Subject: Negative Declaration for Owa Subdivision, TMK: 3-8-07: 38, Wailuku, Maui, Hawaii.

OWA SUBDIVISION

**FINAL
ENVIRONMENTAL ASSESSMENT**

**CHANGE IN ZONING
AND
COMMUNITY PLAN AMENDMENT
APPLICATION**

Figure 1 - East face profile of Backhoe Trench #13, cross-section of railroad bed (Site 3112).

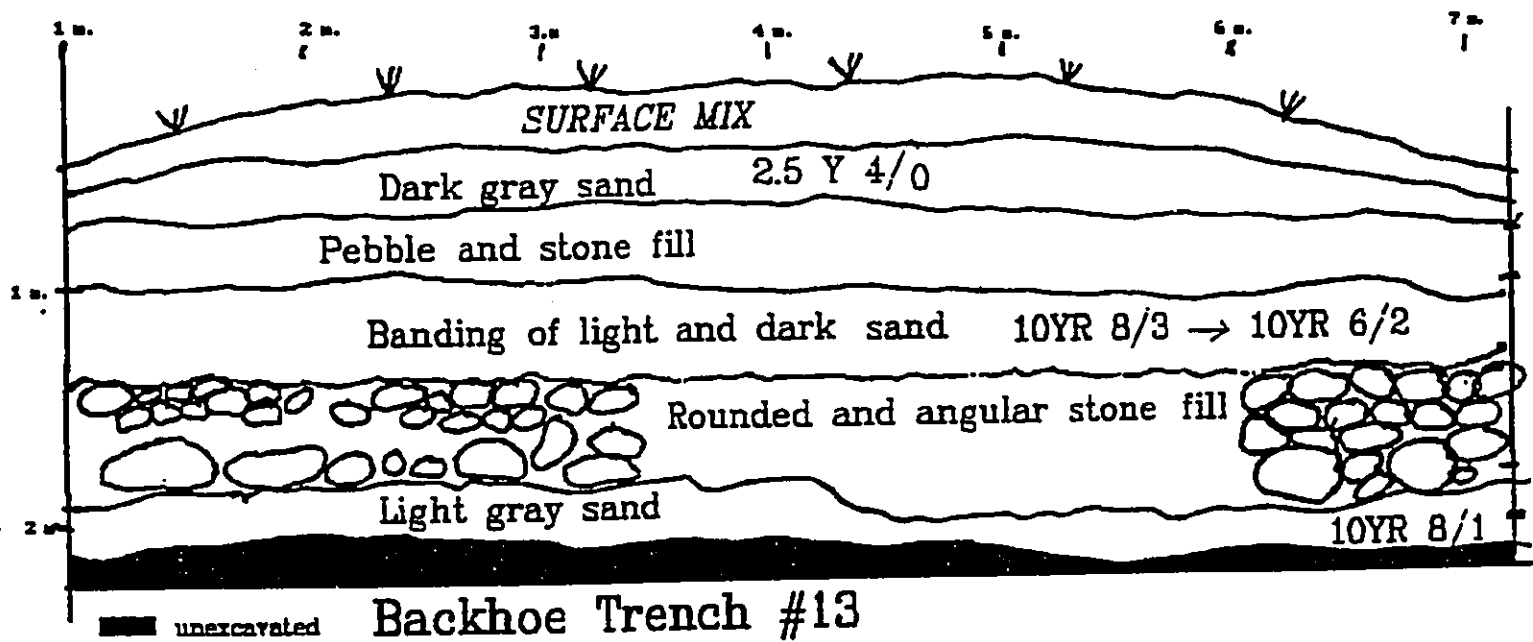
Only three profiles are included with the report, one of which (Backhoe Trench #13, see Figure 1) doesn't extend below modern disturbance. The descriptions of the others and the lack of explanation of the criteria used for judging presence of cultural remains are problematic.
